## **Blackrock village Phase 1 feedback**

DLR Cycle Advocacy Group is a branch of the Dublin Cycling Campaign, which is a registered charity that advocates for better cycling conditions in Dublin. We have a vision for Dublin that is a vibrant city where people of all ages and abilities choose to cycle as part of their everyday life.

*Confusing road markings*

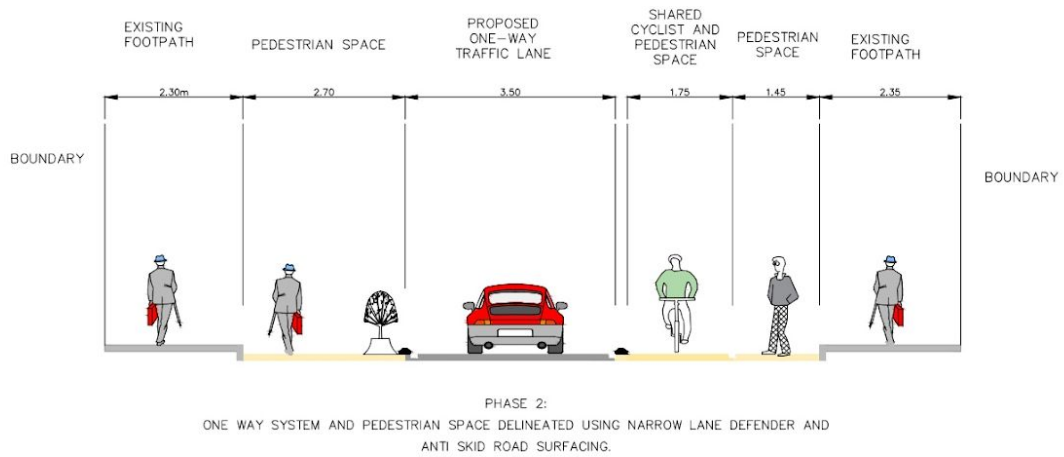
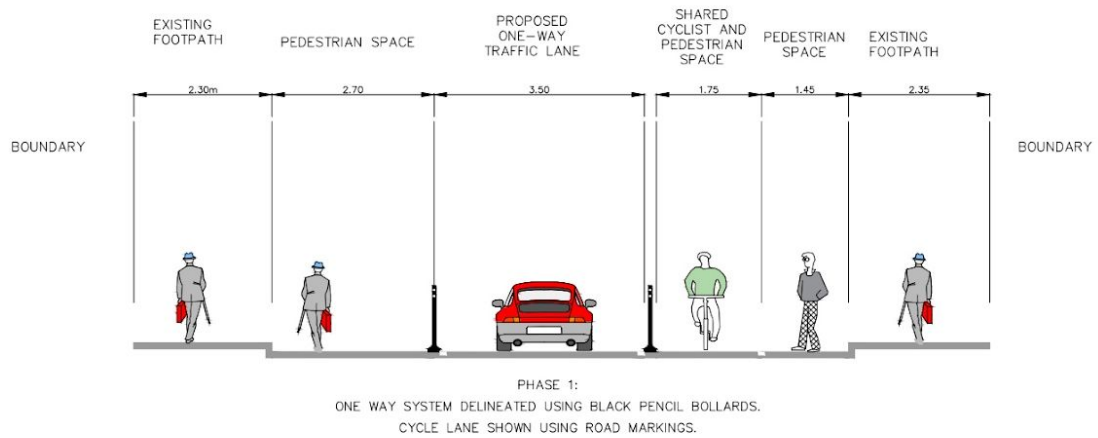
The shared space of the pedestrian/cycling contra-flow lane is not safe. Painting pedestrian symbols on the contra-flow lane is confusing for both pedestrians and cyclists and likely to lead to conflict. The footpath widths have already been extended by taking road space and this should be considered sufficient pedestrian space. We note that disability groups also share this view that shared spaces are not safe for all pedestrians.
